Reference: 250399

Location: Parcel R10 South Wokingham, Phase 2b, Parcel R10

Layout Around Apartment Buildings

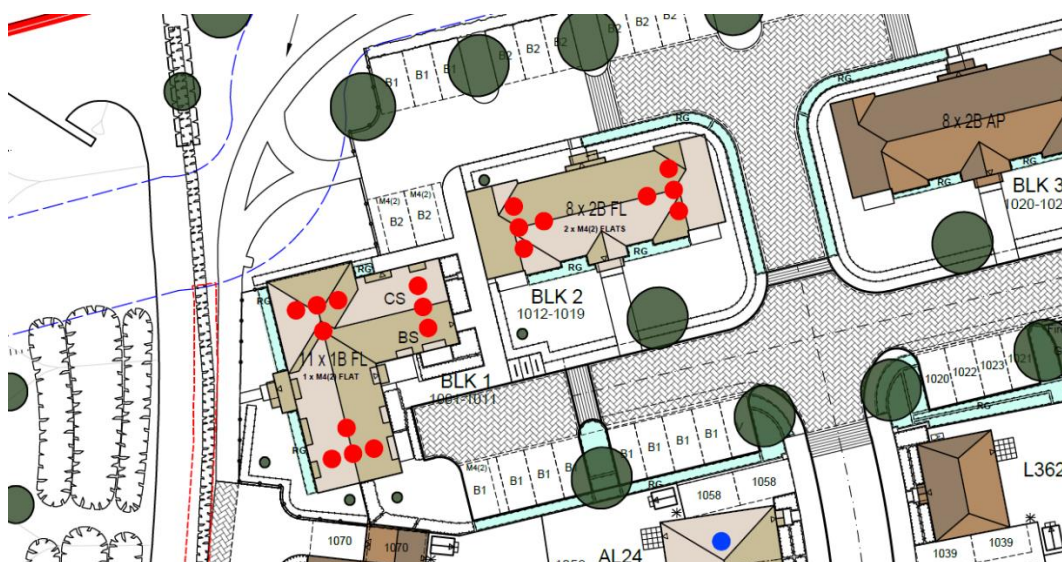
It is noted that the layout of the apartment blocks at the northern end of the site has been revised a number of times as a result of pre-application discussions. However, the current design means that public and private space around the apartment buildings is poorly defined and there are too many accessible pathways through the area, undermining defensible space and providing excessive permeability.

A footpath is provided into the car parking area for the apartments (in the northwest corner of the site). This area would benefit from being private/semi private, but the presence of the footpath will invite use by the general public. In addition, the logical, apparent desire line from the footpath /car park down through the site, will be between blocks 1 and 2 and into the car park to the south. Again, this area, between the two apartment blocks and the car parking area should be private/semi private.

The presence of parking areas to the south of the blocks also exposes the vulnerable side boundaries of the housing to the south.

I would recommend that the layout of blocks 1 – 4 are reconsidered so that a clearer definition of public and private space can be provided and excessive permeability can be avoided. Preferably, the parking courts would be provided within private courtyards which do not expose rear/side boundaries of properties, can be overlooked from the apartments, and can be gated.

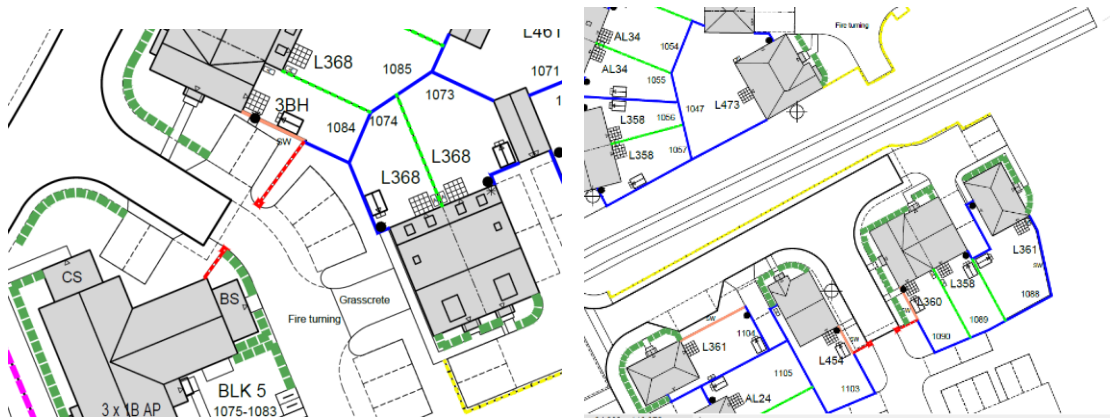
The parking for apartment block 6 is effectively provided in a rear parking court, which exposes the vulnerable rear and side boundaries of neighbouring properties. It is therefore recommended that the entrance into the car park is gated with electronic gates with only residents of the apartments having access. The visitor parking may need to be relocated outside of the parking court to a more public location. Gated access will also be required from the path leading into the car park area from the apartments. The eastern boundary should be defined by railings (1.8m high) and defensive hedging.

The parking area for Apartment block 7 also exposes the vulnerable rear and side boundaries of neighbouring properties and therefore should be gated, as outlined above.
